Permit No: 0005675

Site Address: 7260 POCKET RD SAC

Nature of Work: NSFR 2 STORY 5553 SQ FT W/ ATT GARAGE

Re: Murphy Residence
7260 Pocket Road
PERMIT NO. 00-05675

KITCHEN HOOD
SIDE ELEVATION @ 19-02 W/ MOULDINGS

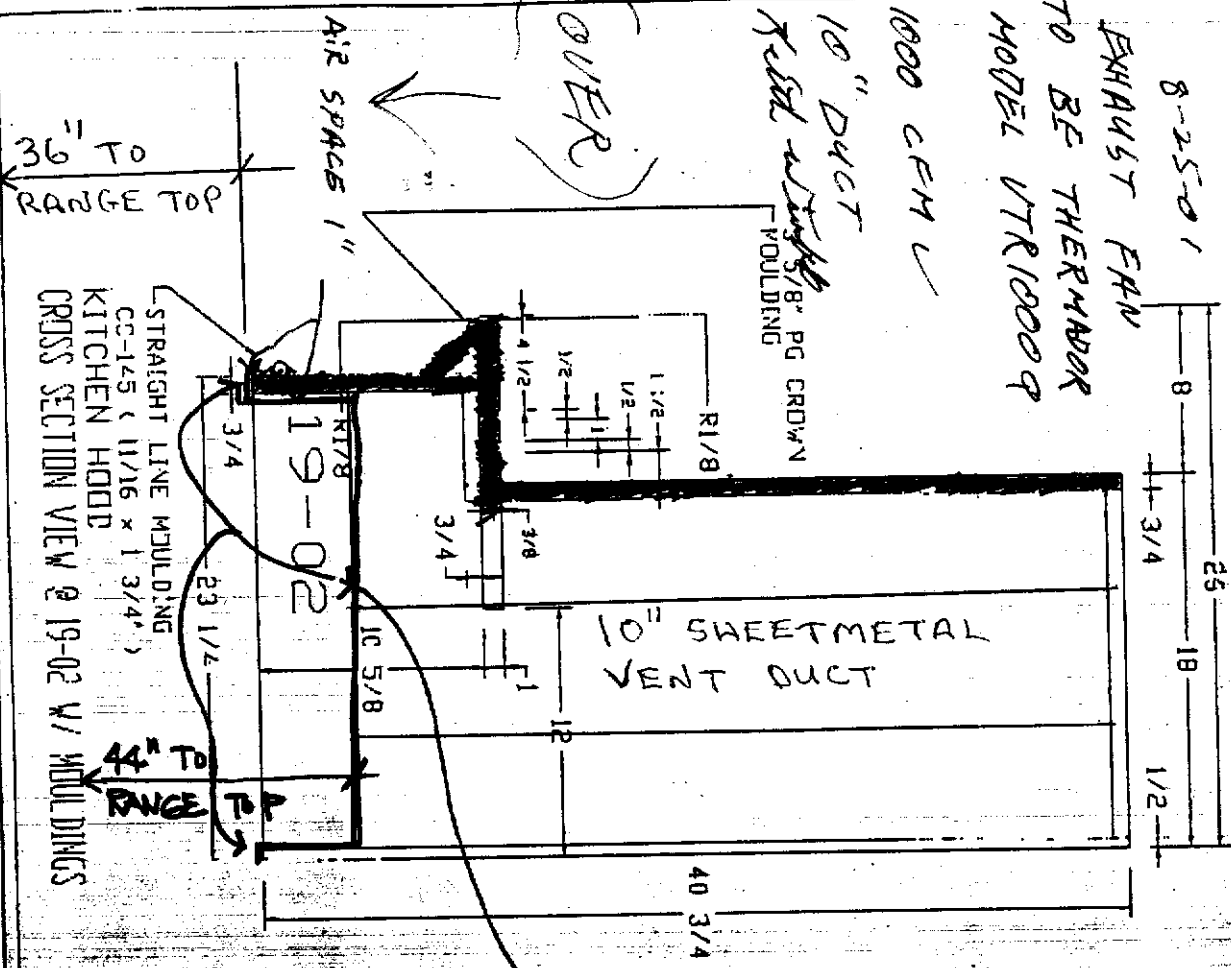
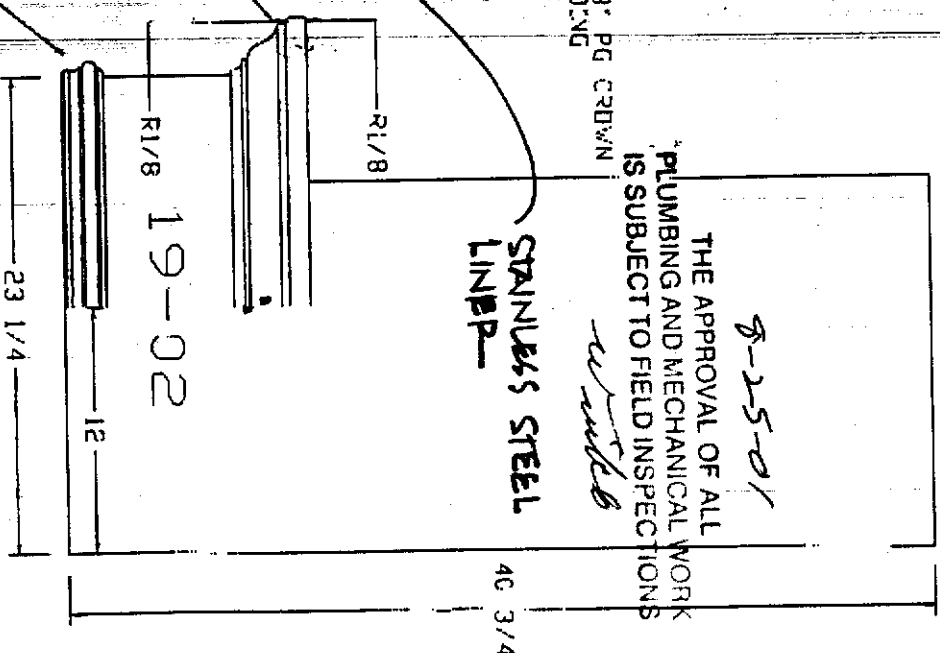
8-25-01
EXHAUST FAN
TO BE THERMADOR
MODEL VTR1000Q

HILES THRU I-JOISTS AT KITCHEN

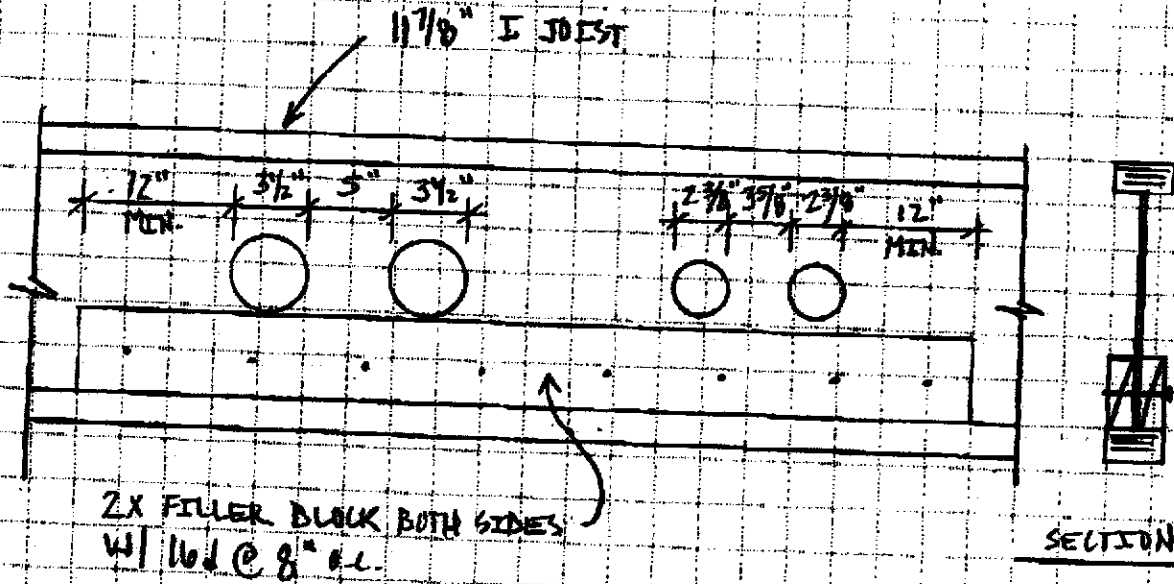
- 1) Holes for plumbing lines have been installed thru the webs of some of the I-Joists at the kitchen floor. The hole spacing does not meet the manufacturer's standard allowable hole chart. Based upon a review of the calculations, drawings and manufacturer's catalog, the joists will remain acceptable as long as a 2X filler block is added at the bottom of the holes on both sides of the web. The depth of the filler block should be maximized to fill the space from the bottom of the hole to top of the bottom flange. See attached detail.

DWG # A0010-026
SHEET # 1 OF 1

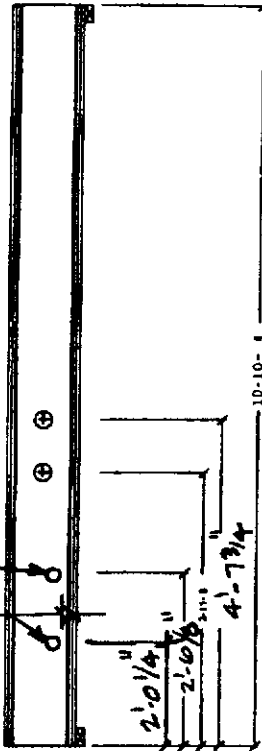
The CTR 250 joist that had four holes drilled in the web closer than our hole chart permits was reviewed and found to be structurally sound with the drilled holes. There is no repair required for this joist. A copy of the calculation is attached to this letter for your reference. A wet sealed calculation will be mailed to you.

NO REPAIR REQUIRED
